CITY OF SUN VALLEY
PLANNING AND ZONING COMMISSION
AGENDA REPORT

Agenda Item: **New Villager Snow Storage**
Design Review Application No. DR 2013-41

SUBJECT: Review and action on draft Findings of Fact reflecting the Planning and Zoning Commission's public hearing and action on November 14, 2013 for a Design Review Application for improvements to common area that would allow intensification of snow storage behind an existing garage structure on the site of a condominium complex in the Multiple-Family Residential (RM-1) Zoning District of the City of Sun Valley. **Applicant:** James R. Laski for the New Villager Condominium Association, Inc. **Application Filing Date:** October 25, 2013. **Location:** New Villager Road; Area "B" behind the garages of Complex 7 and 8, adjacent to the Lower Fairway Road Subdivision, Corrected.

EXHIBIT
"PZ-B"
tabbies

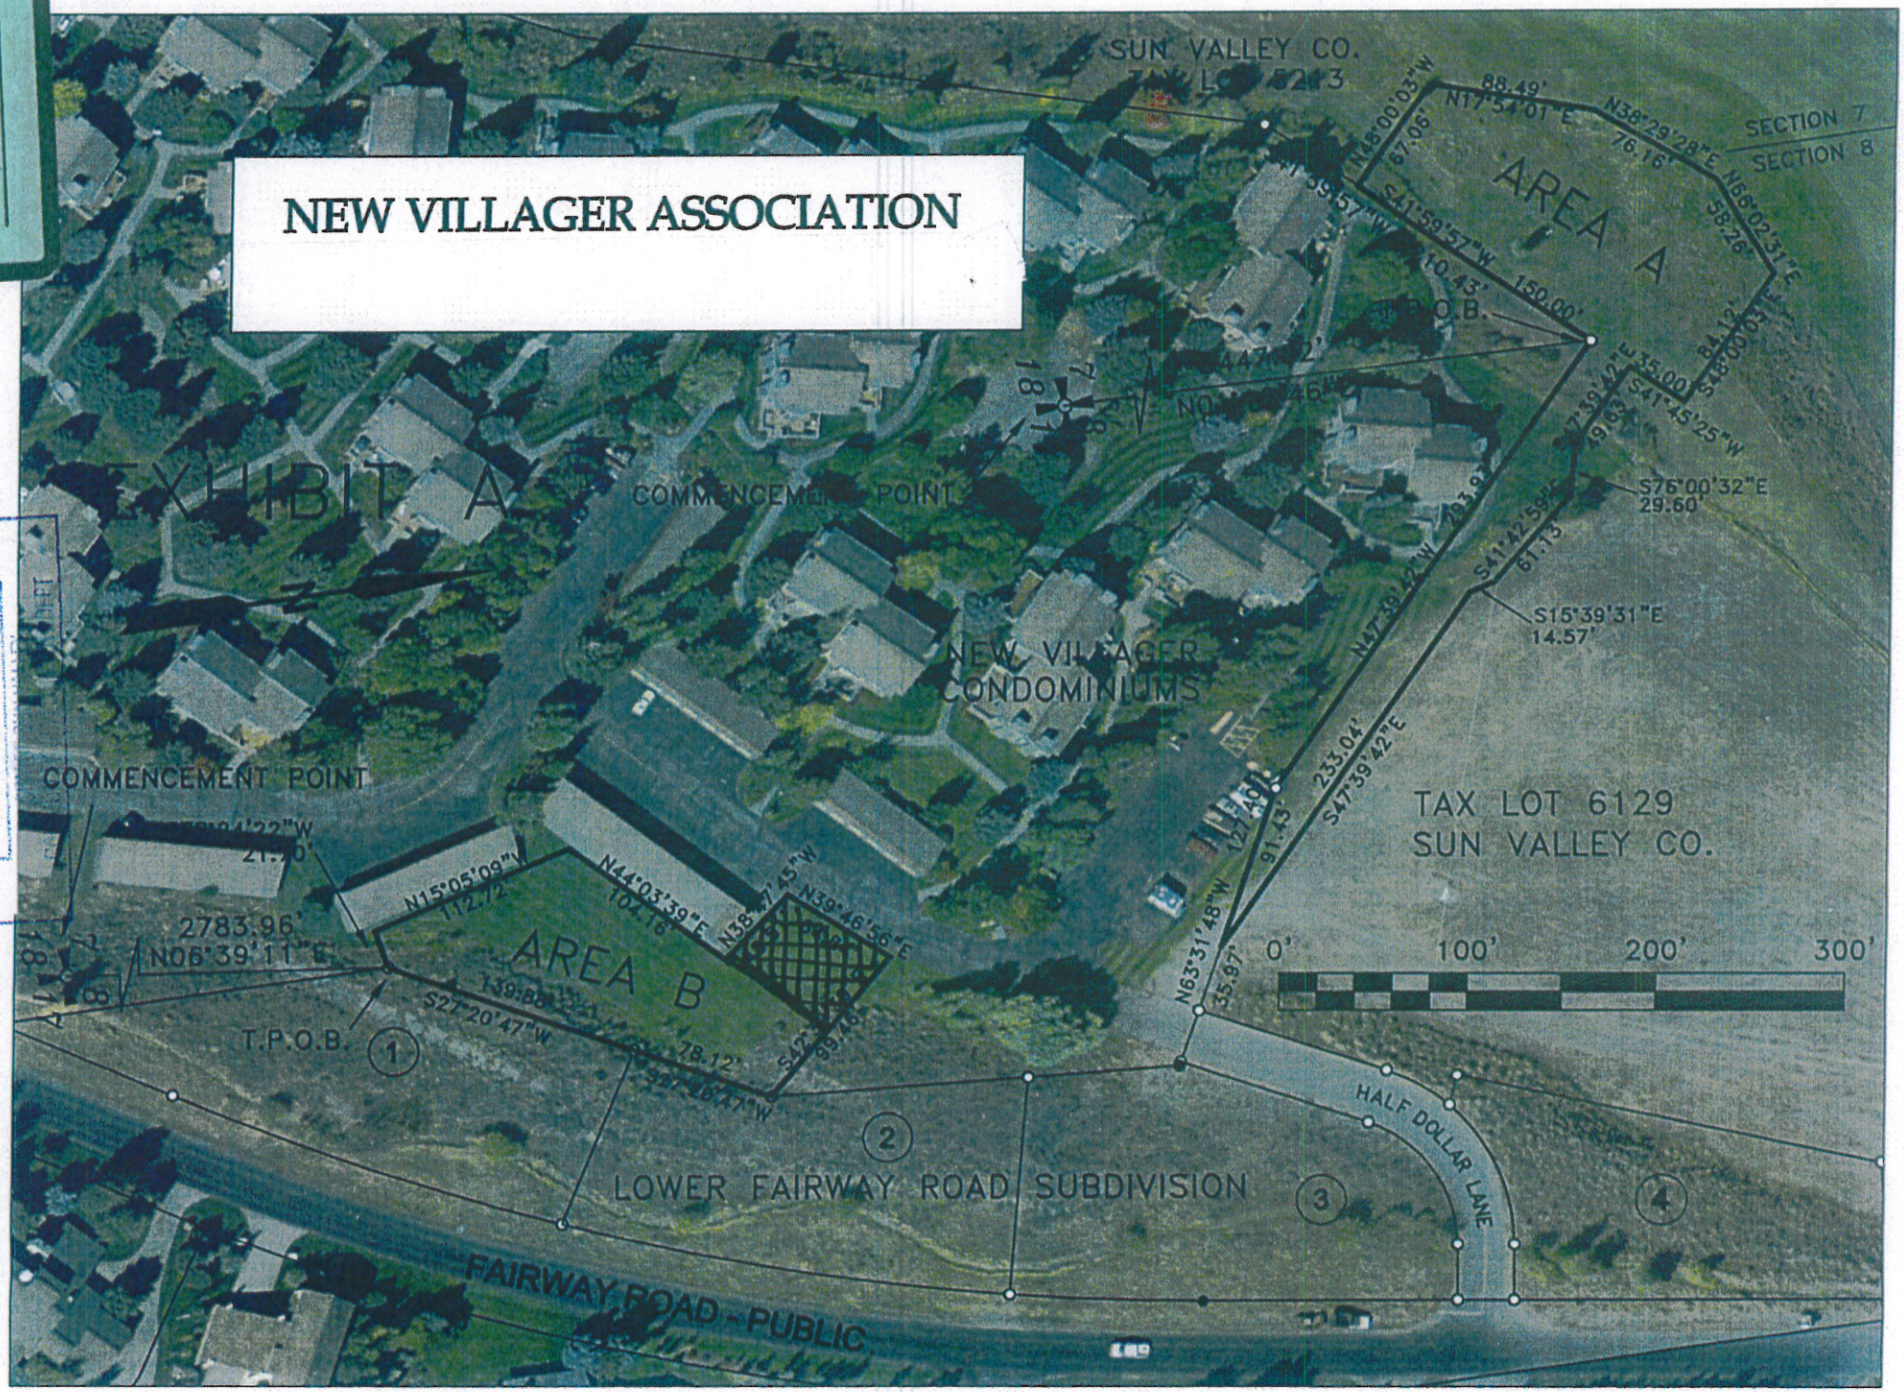
Given the foregoing, the NVCA hereby requests the Design Review Approval related to the use of that portion of the New Villager Common Area identified as Area B on the attached Exhibit for storage of snow. The NVCA has previously installed drainage in Area B to address run off issues related to the adjacent garage structures. Anticipating that this area might be required to be used for future snow storage, the NVCA designed such drainage to be adequate to accommodate snow storage in the area. Accordingly, no new construction is required.

Snow storage is incidentally appropriate and compatible to RM-1 multi-family residential use. Indeed, if this project were to be approved today, a snow storage area would be required. *See* Sun Valley Code 9-3A-3. Area B is the only open common area with the New Villagers that is appropriate for storage of snow. Further, based on the relative elevations of the adjacent properties, the storage of snow will not impact view or privacy.

EXHIBIT
"PZ-D"

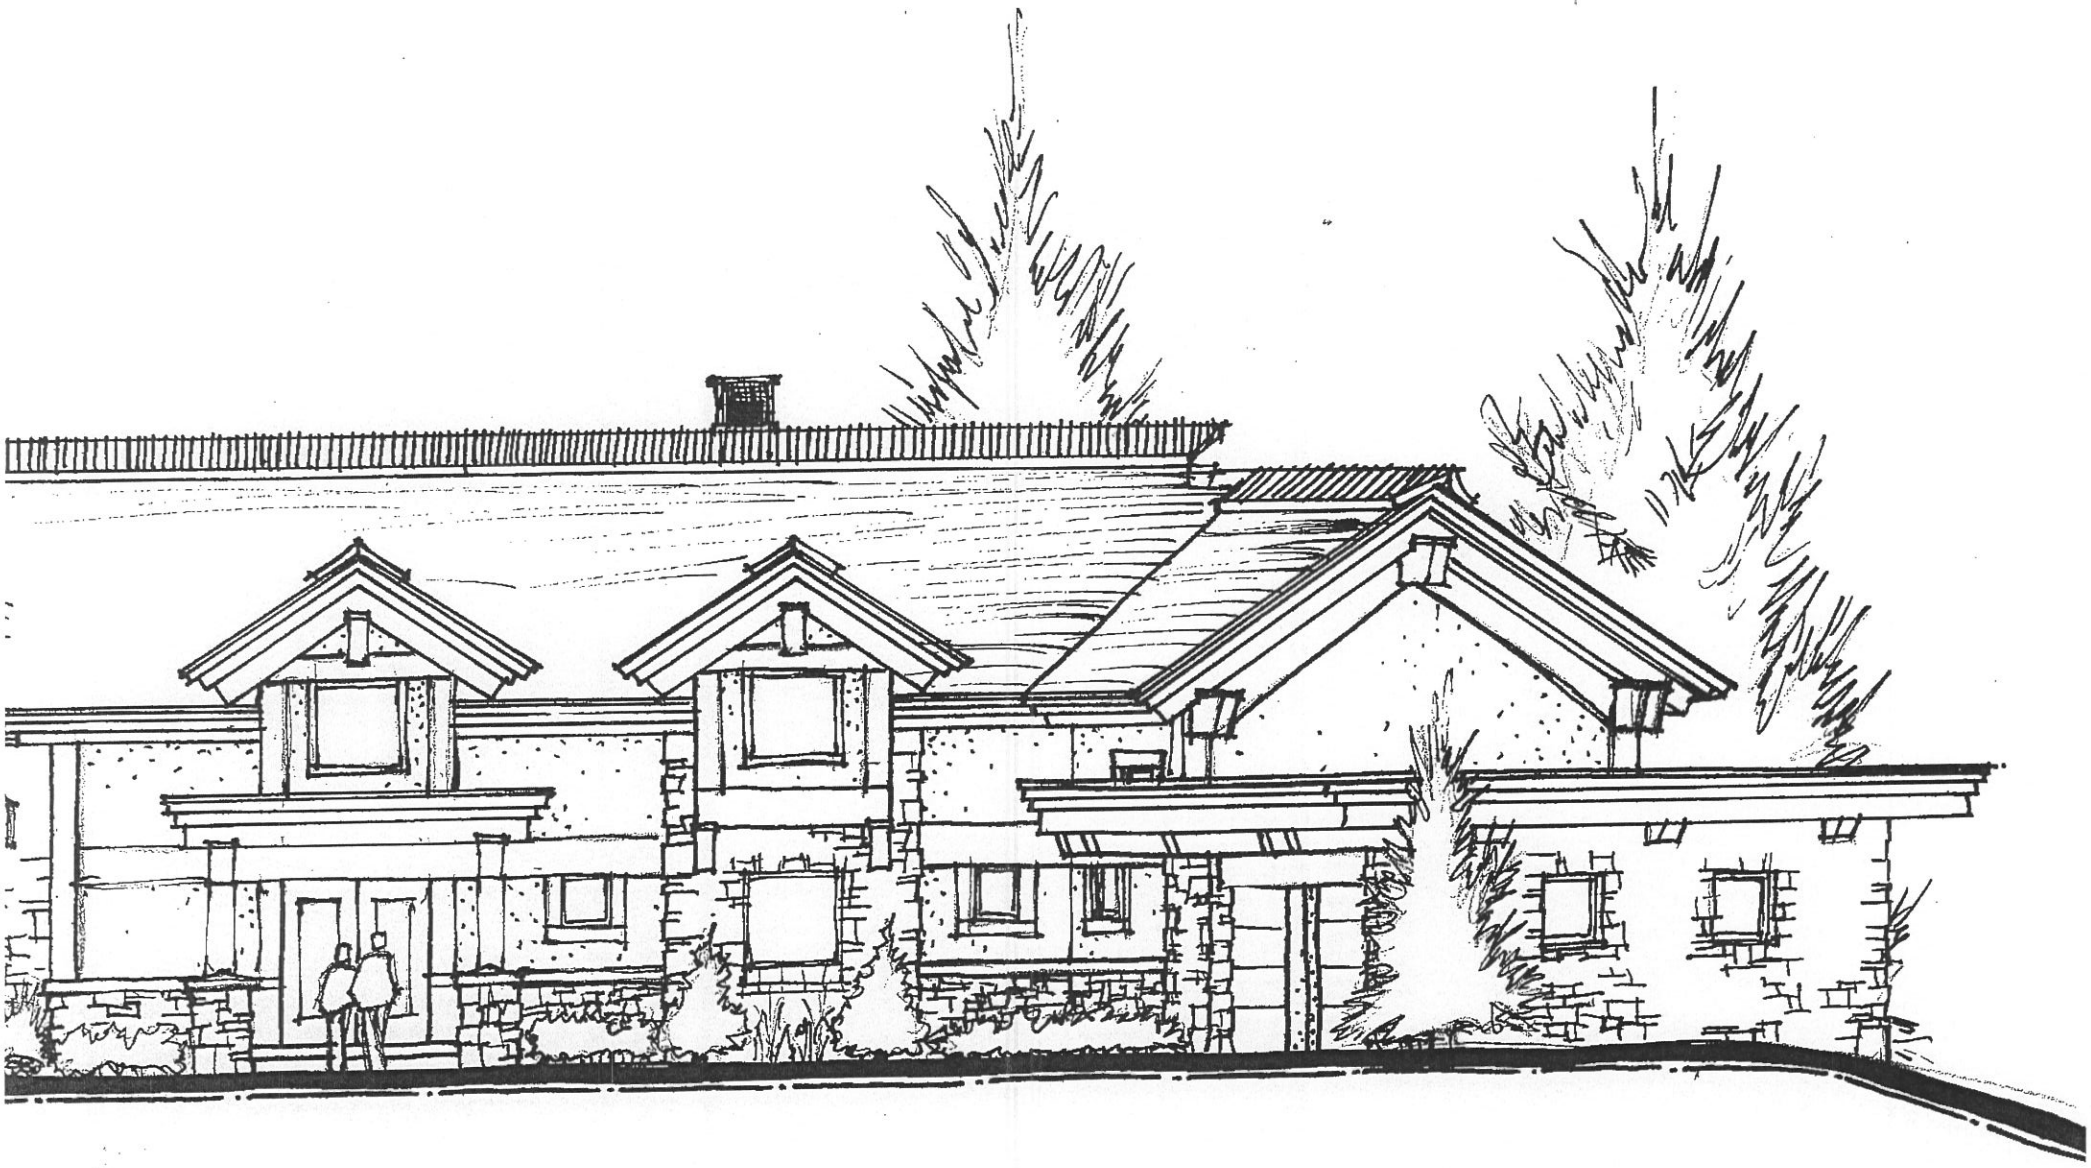
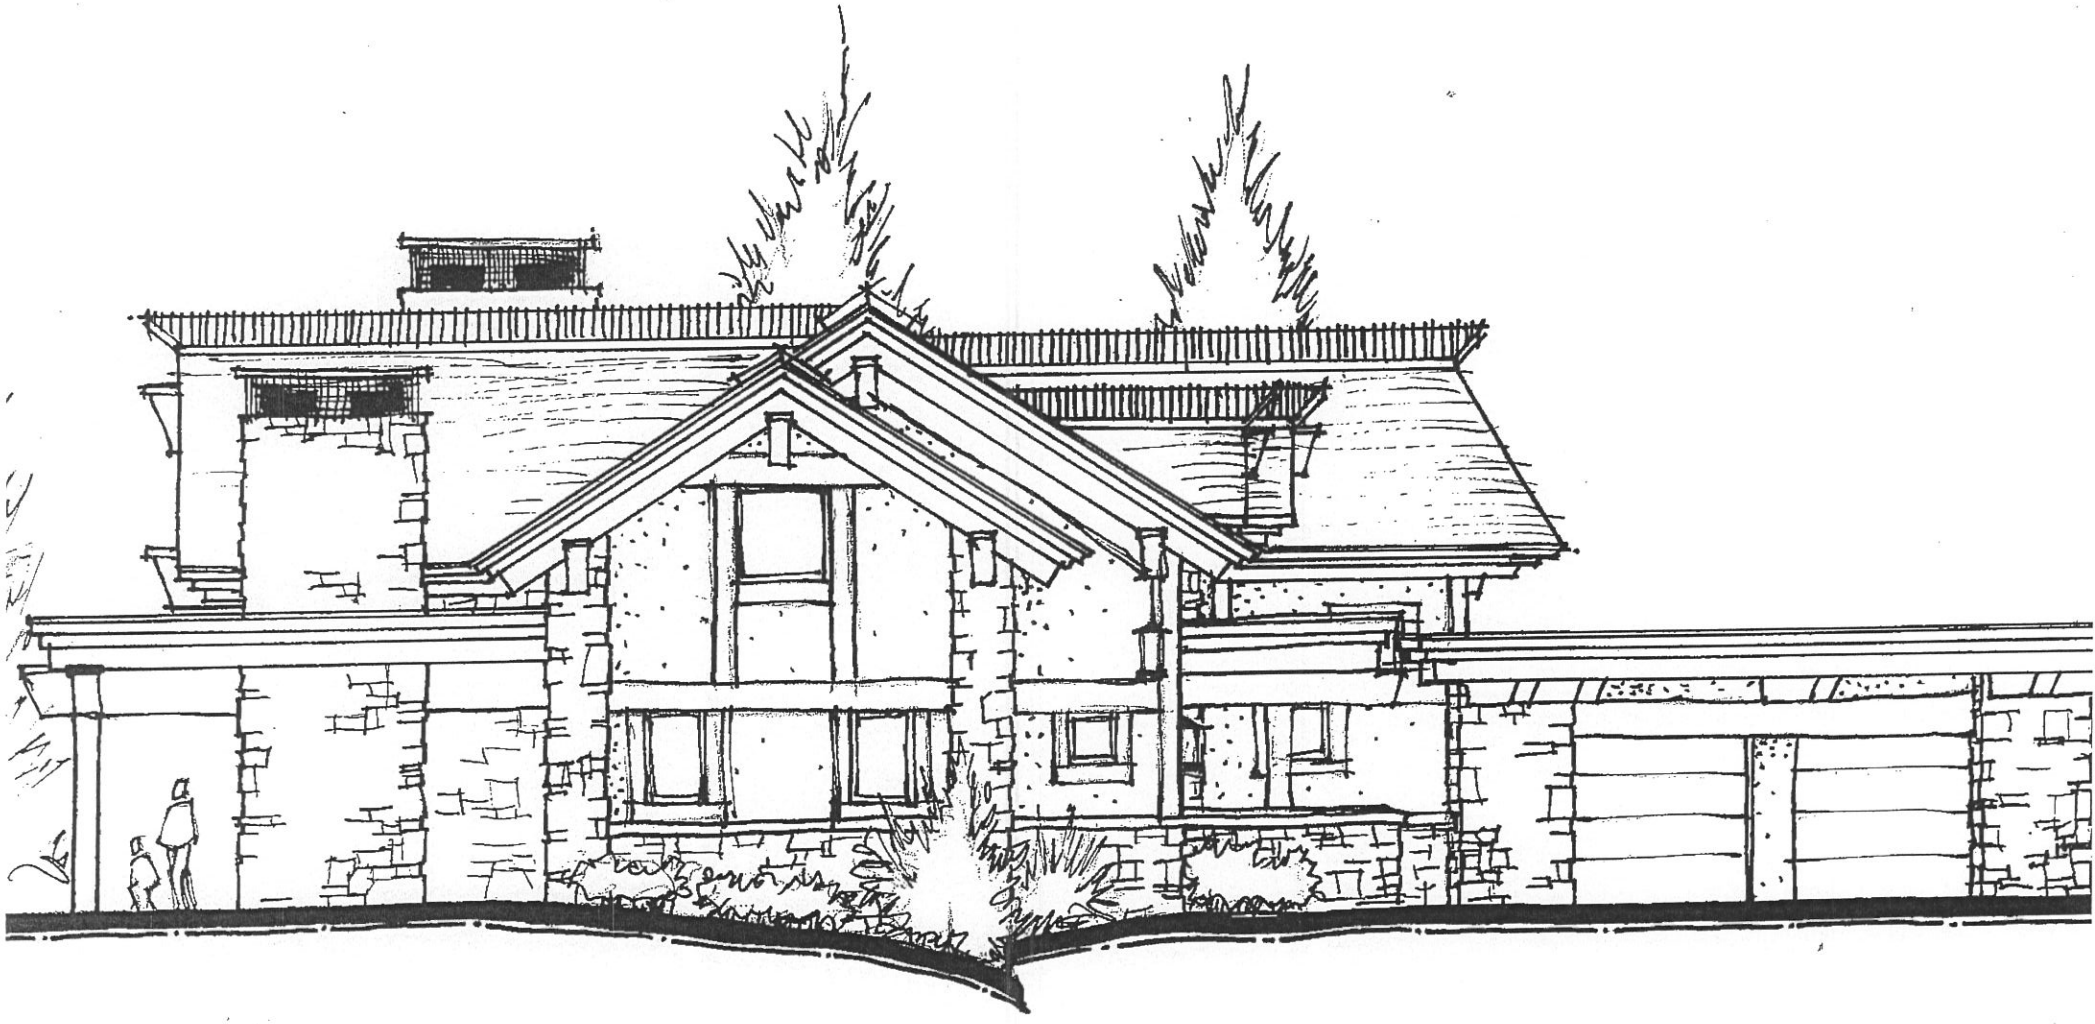
It has come to our attention that New Villager Condominium Association, Inc. is improving land directly adjacent to our property (lot 1, Lower Fairway Road Subdivision) to allow intensification of snow storage. This information is extremely troubling as we are in the final phases of architectural design of our dream vacation and retirement home. Attached are the renderings of the home with intensions of breaking ground this coming spring with Intermountain Construction. The great room and master bedroom are perfectly positioned to capture the majesty of bald mountain. This also happens to be in direct site of the New Villager snow piles. This is troubling for a multitude of reasons, including but not limited to, the following:

- Noise pollution secondary to heavy equipment manipulating snow piles, particularly in the early morning hours, when our 5 and 7 year-old boys are preparing for a long day of ski-team.
- Potential health hazard to our young children playing on our property adjacent to snow piles.
- Eye sore from the large piles of snow, with potential obstruction of view.
- Snow will be bull-dozed making it muddy in the spring.
- Snow may not melt until well into the summer months when we are trying to enjoy the symphony and the other magnificent activities the resort has to offer.
- Will most certainly devalue the property.
- Potential for snow to spill onto our land which would prompt legal action.

The irony is that in order to make lot 4 (currently under development) more pleasant, Sun Valley Company is no longer allowing the New Villagers to store snow in proximity. It certainly is not fair to improve one lot at the expense of another. None of the property owners of Lower Fairway Subdivision should have to take on the burden of the New Villagers snow removal or storage. We are happy to work with the City of Sun Valley and the New Villagers at exploring other snow removal options. There must be a feasible alternative that wouldn't make such a significant impact.

5. **The approved Area B snow storage shall be used solely by the New Villager Condominiums.**
6. **The use of equipment for snow piling operations hours shall be limited to between 8am and 6pm to minimize noise impact on surrounding land uses.**

7. **The maximum height of the piled snow shall be twelve (12) feet above the existing grass surface.**
8. **The stored snow piles shall be cleaned of debris in the Spring for aesthetic purposes as the snow melts and exposes buried debris collected up with snow removal operations.**
